# UNITED STATES PATENT AND TRADEMARK OFFICE

10/562,172

Harald Koellner

<b>Office Action Summary</b>	<b>Application No.</b>	<b>Applicant(s)</b>	
	10/562,172	KOELLNER ET AL.	
	<b>Examiner</b>	<b>Art Unit</b>	
	Gregory J. Strimbu	3634

**FIG- 2**

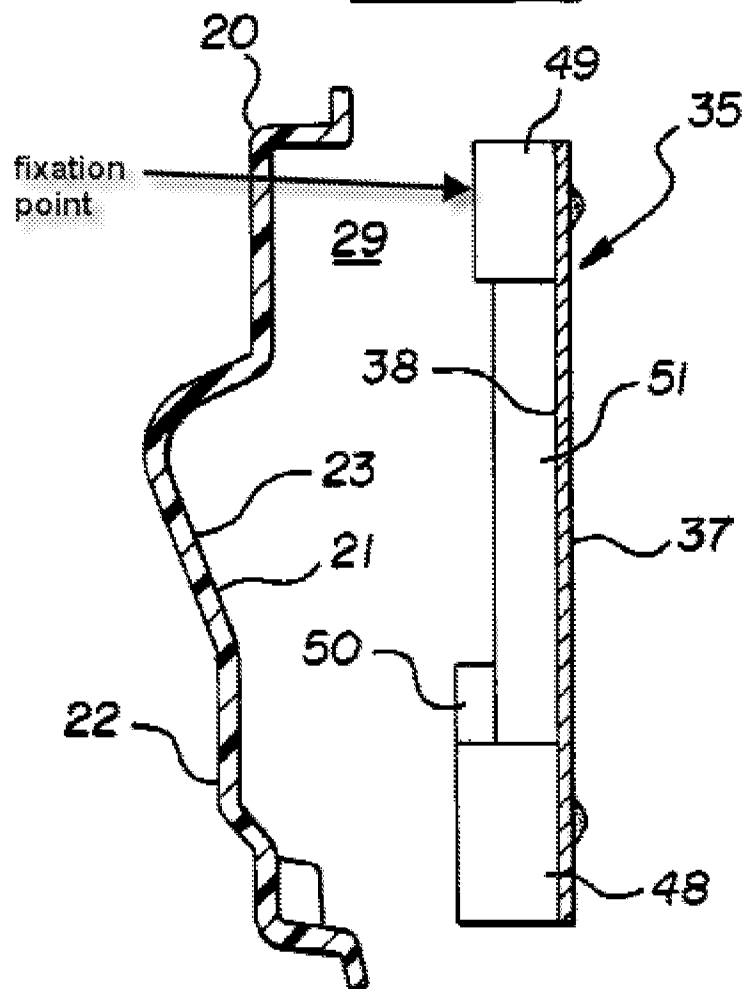
Claims 1, 2, 4-7, 12 are rejected under 35 U.S.C. 102(b) as being anticipated by Koa et al. (US 6412852). Koa et al. discloses a module for covering an opening (not numbered, but shown in figure 1) in a motor vehicle door 10 and for supporting a door inner trim 20, comprising: a base body 35 including a base 42 and at least one bracket 41 movable with respect to the base, the bracket 41 including a supporting surface 37 for contacting an edge region surrounding the opening, the bracket including at least one fixation point (labeled below) for fastening only to a door inner trim 20, and fixation elements 49, 51 for fastening only the module on an edge region of the opening, wherein the fixation elements and the at least one bracket are laterally offset from each other with respect to a plane defined by the module;

regarding claim 2, the module includes a sheet 35 of one of a metal and a plastic (see column 5, lines 41-43);

regarding claim 4, a peripheral seal 45 limiting the passage of moisture through the opening;

regarding claim 5, the bracket 41 is integrally formed on the base body 42;

regarding claim 6, the bracket 41 is coupled to the base by a film hinge 40;

regarding claim 7, the bracket 41 includes a clipping opening 39 sized to receive and clip therein a corresponding part 25 of the inner trim 20;

regarding claim 11, the bracket is fastened to the base by at least one spring element 40;

regarding claim 12, a plurality of fixation elements 25 fastening the module to the edge of the opening.

**Fig. 4**

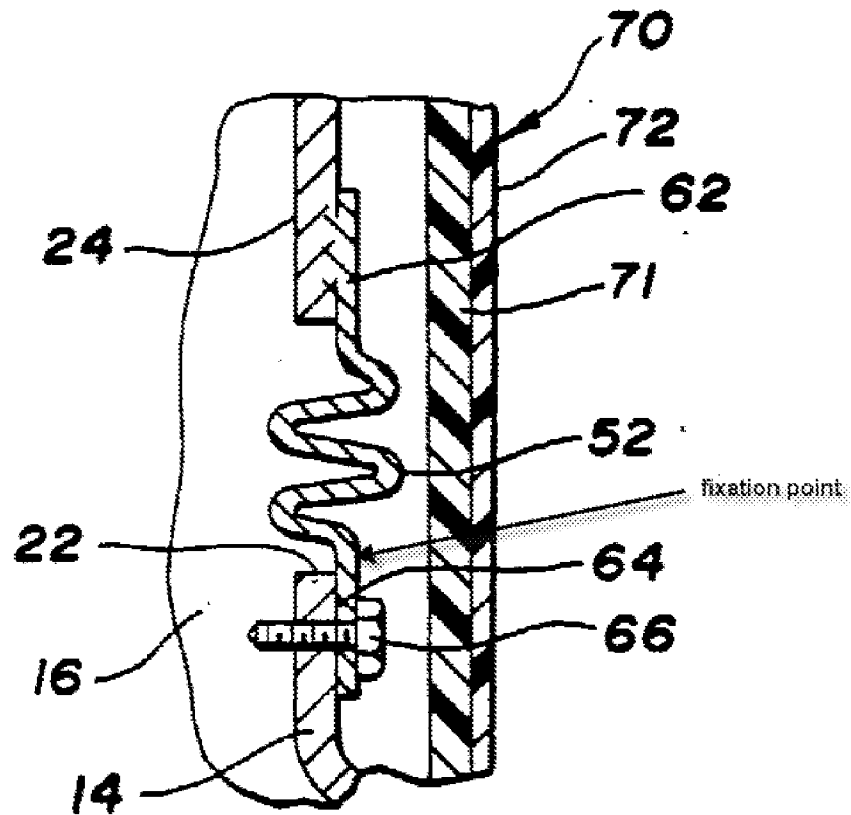
Claims 1, 2, 5, 6, 8, 9 and 11-14 are rejected under 35 U.S.C. 102(b) as being anticipated by Lau et al. (US 5048234). Lau et al. discloses a module 24 for covering an opening 22 in a motor vehicle door and for supporting a door inner trim 70, comprising: a base body including a base 24 and at least one bracket 52 movable with respect to the base, the bracket including a supporting surface (not numbered, but shown in figure 4) contacting an edge region surrounding the opening, the bracket including at least one fixation point (labeled below) for fastening only to the door trim 70, and fixation elements (not shown, but comprising the portions of the base 24 that overlap the inner panel 14 as set forth in column 3, lines 4-6) for fastening only the module on an edge region of the opening, wherein the fixation elements and the at least one bracket 52 are laterally offset from each other with respect to plane defined by the module as shown in figure 4;

regarding claim 6, the bracket 52 is coupled to the base by a film hinge (not numbered, but shown in figure 4);

regarding claim 11, the bracket 52 is fastened to the base 24 by at least one spring element (not numbered, but shown in figure 4);
